# Service Bulletin

**Subject:** Poor Radio Hands-free Voice Recognition Performance or Sound Quality After OnStar Upgrade

*This PI has been revised to add RPO UP9 to the Buick Verano in the repair information table. Please discard PI1533A.*

## Repair 1 - OnStar Module, Relocate the Microphone and Ground Circuits from X3 to X2 Connector

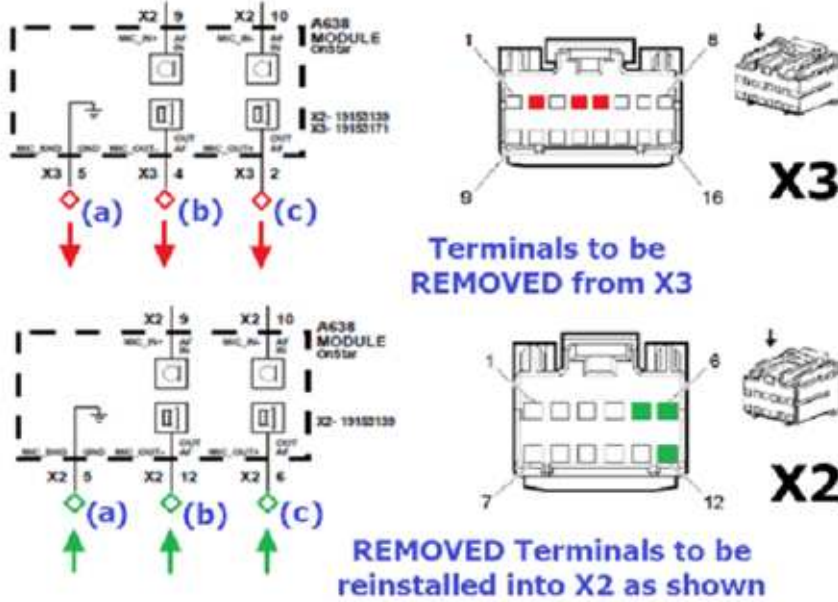
- a: Move terminal 5 on X3 to terminal 5 on X2.
- b: Move terminal 4 on X3 to terminal 12 on X2.
- c: Move terminal 2 on X3 to terminal 6 on X2.

## Repair 2 - OnStar Module, Pin 12 on X2 Connector Ground Instructions

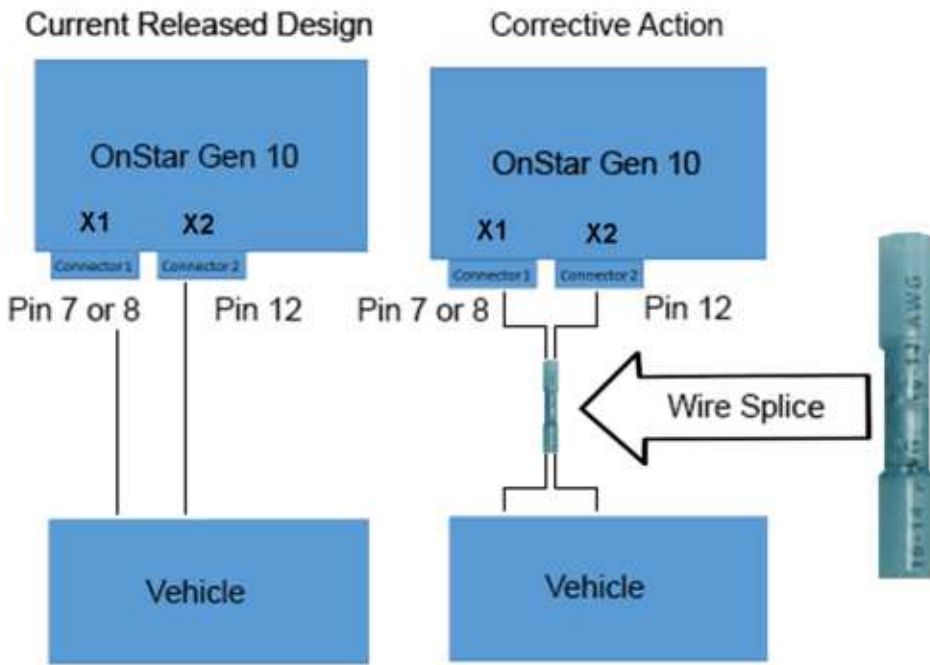
Ground pin 12 of X2 connector by splicing Pin 12 to X1 Pin 7 or 8.

Install a blue Duraseal splice connector to the wires, (P/N 19168447, from the J-38125 Terminal Repair Kit).

**Note:** To determine whether splicing will take place at Pin 7 or 8 of (X1) connector 1, the technician will need to visually check existing terminal location. (Location varies based on harness build).
